# APA 60% design review

## Responses to committee questions

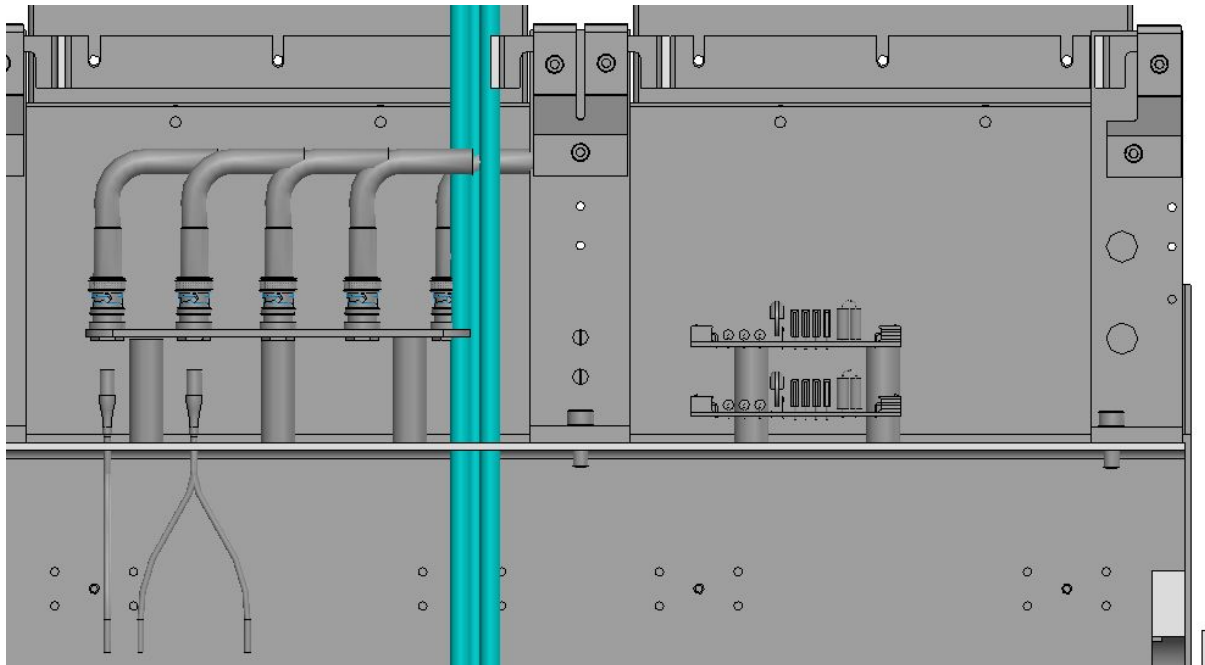
**4) Could you please present a drawing of the region on top of the head tube of the upper APA where there is some interference between the SHV board and the photon detector cables from the upper APA ?**

This picture was from Kyle last week showing a minor interference between the SHV panel on top of the APA head tube and the PD cables coming out of the APA head tube without bending. Obviously, the PD cables can be bent slightly to get around the SHV board, or, the SHV board can be shortened slightly by modifying the current SHV connector arrangement into a 2x4 pattern instead.

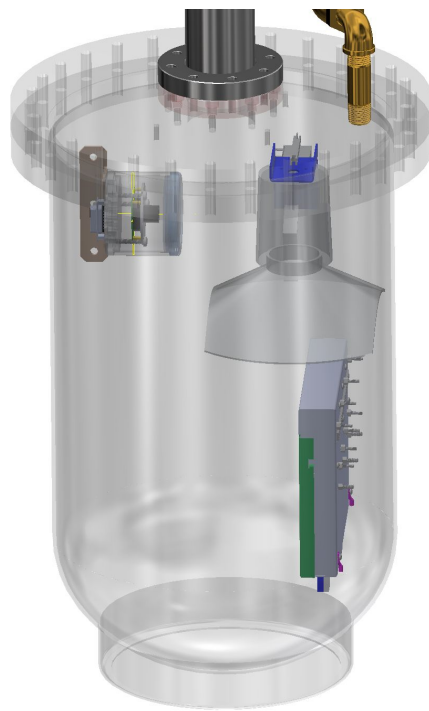
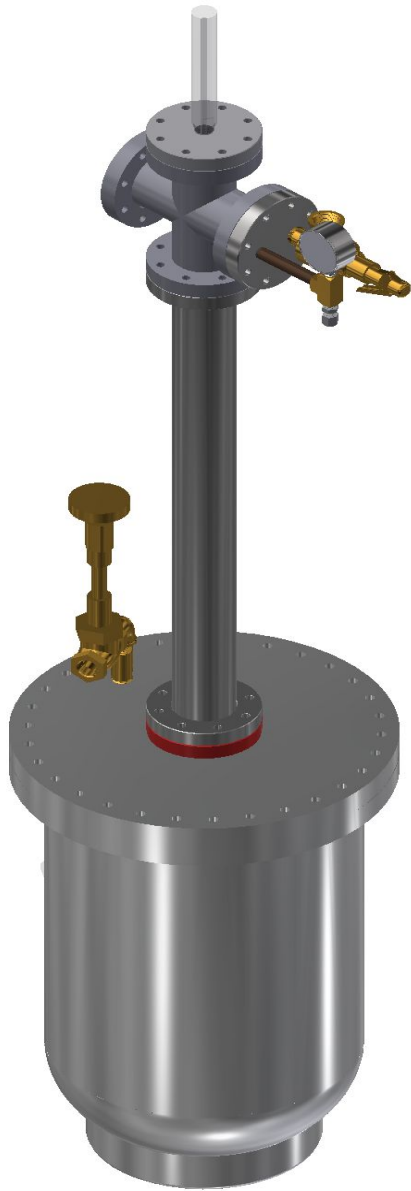
**9) Could you explain where the 10% boards out of tolerance come from? The committee feels this is quite high.**

The percentage of defective boards varied by production lot. The most common defects involved machined mechanical features such as counter-bores and channels (controlled-depth milling). The dimensions of these features were often out of spec, probably resulting from inadequate tool maintenance or machine alignment. Less common defects included missing mechanical features, scratches, inadequate flatness, inadequate thickness control, and inadequate solder mask adhesion.

Some of our mechanical tolerances either matched or surpassed the stated capabilities of the manufacturer. We agreed to accept boards that met their stated capabilities, knowing that in most cases the results would be acceptable. As a result we expect to continue receiving some boards that do not meet spec, with past performance guiding our expectations.
